ENGINEERING REPORT
FOR
ARKANSAS NUCLEAR ONE
RUSSELLVILLE, ARKANSAS

NO.	DATE	REVISIONS	BY	CH'K	APPR.
1	8/11/93	Minor Revisions for Clarification	ACB III	RO	CE
0	9/2/92	Initial Issue	ACB III	RO	BW/WH
TITLE			REPORT NUMBER		REV.
ANO-2 STEAM GENERATOR DEGRADED TUBE ANALYSIS PER FEG GUIDE 1.121			92-R-2025-01		1.0 ACB III 8/11/93
FORM TITLE:			FORM NO.		REV.
ENGINEERING REPORT COVER SHEET			5010.017A		0

Attachment B - MPR Associates, Inc. Report dated August 26, 1992, "Evaluation of Arkansas Nuclear One Unit 2 Steam Generator Tube Wall Degradation".

EVALUATION OF
CIRCUMFERENTIAL DEFECTS AT THE
EXPANSION TRANSITION IN ARKANSAS NUCLEAR ONE
UNIT 2 STEAM GENERATOR TUBES

FIGURE 1

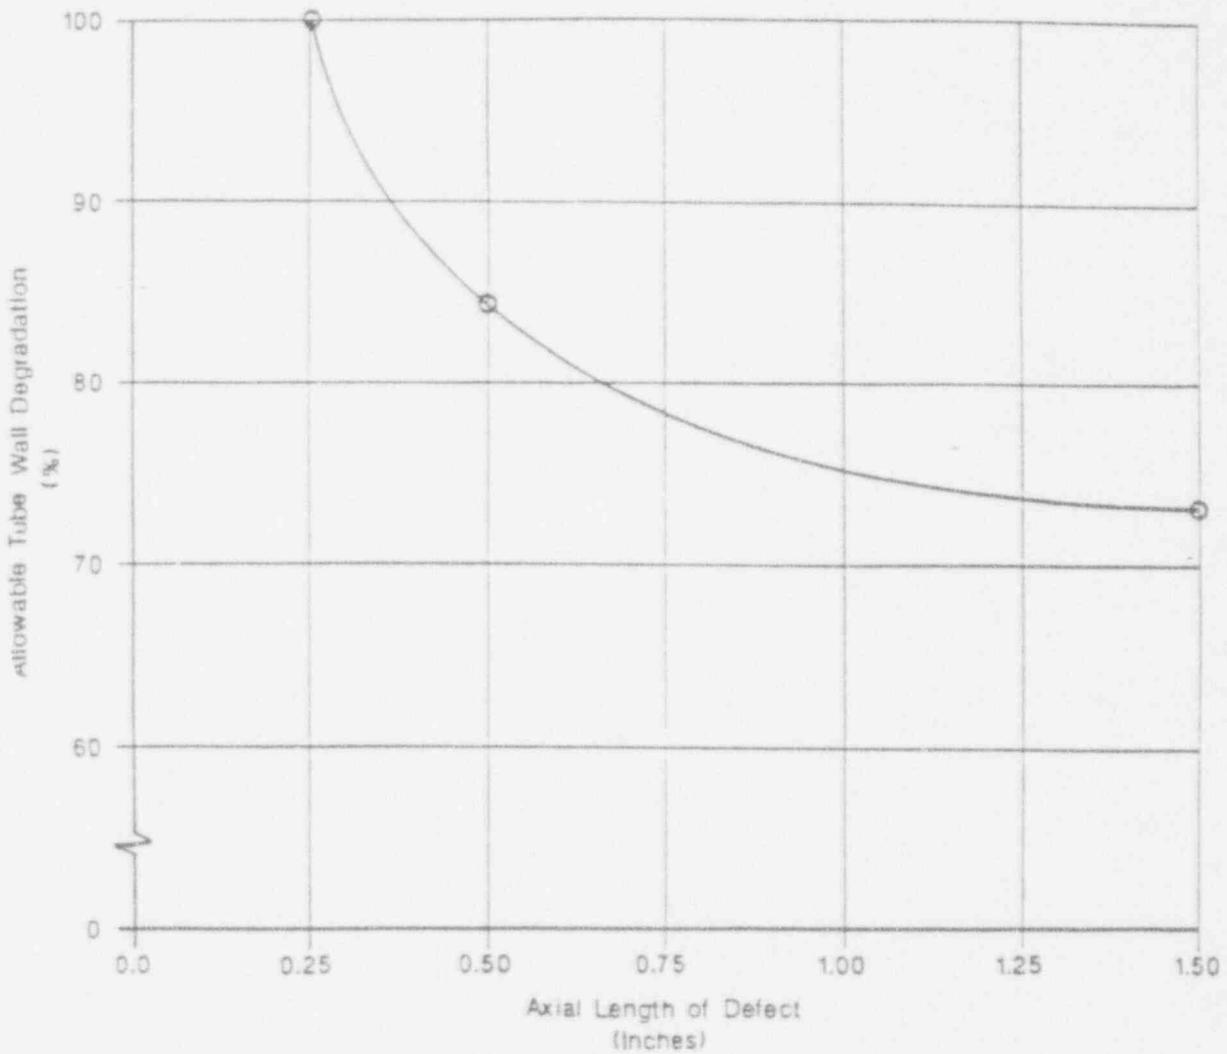
- ⁵ These values actually apply for the maximum of the slot defect lengths indicated. Other values can be obtained from Figure 1 if desired.

ALLOWABLE TUBE WALL DEGRADATION
FOR AXIAL SLOT TYPE DEFECTS (AXIAL CRACKS)

FIGURE 26. Burst Pressures for 0.750 x 0.050 in. EDM Slots

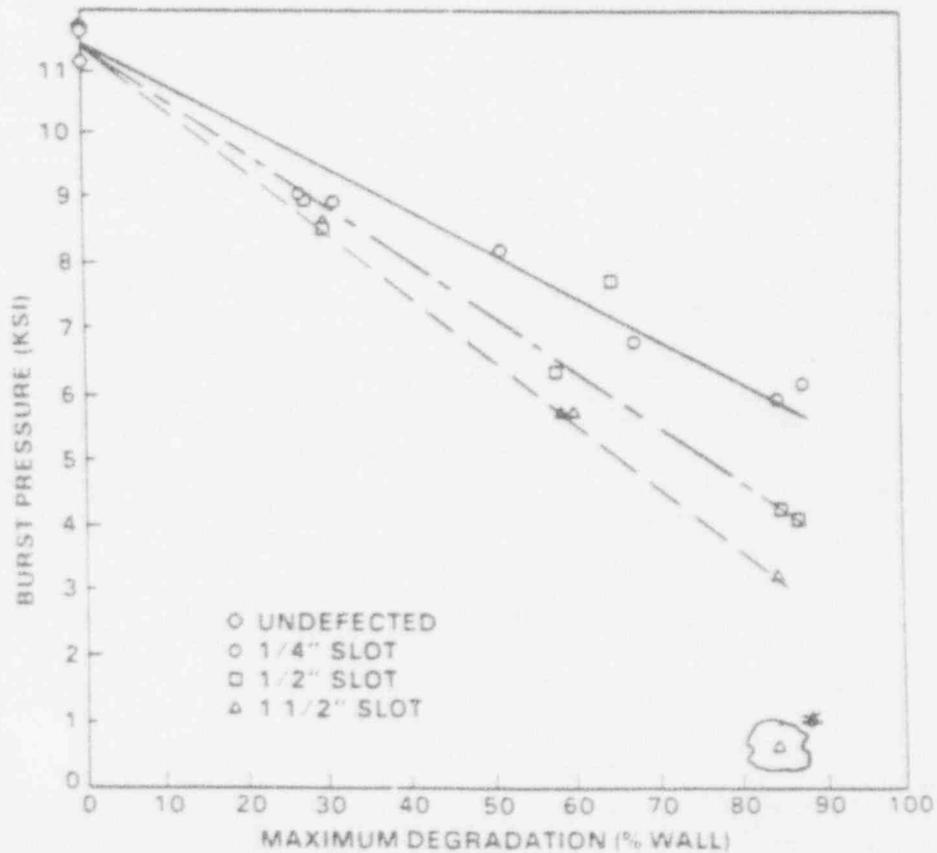
BURST PRESSURE RESULTS FOR 0.750" \pm .050 IN. TUBING ARE SHOWN IN FIGURE 26 OF REFERENCE 1. (ANDO UNIT 2 TUBING IS 0.750" \pm .048 IN. PER REFERENCE 2, PAGE 21.). FIGURE 26 IS SHOWN

BELOW INCLUDING "BEST-FIT" STRAIGHT LINES
RELATING BURST PRESSURE TO WALL DEGRADATION
FOR THE 1/4", 1/2" AND 1 1/2" SLOT DEFECTS.

* NOTE THAT THIS DATA POINT IS NOT CONSIDERED VALID AS DISCUSSED ON PAGE 46 OF REFERENCE 1.
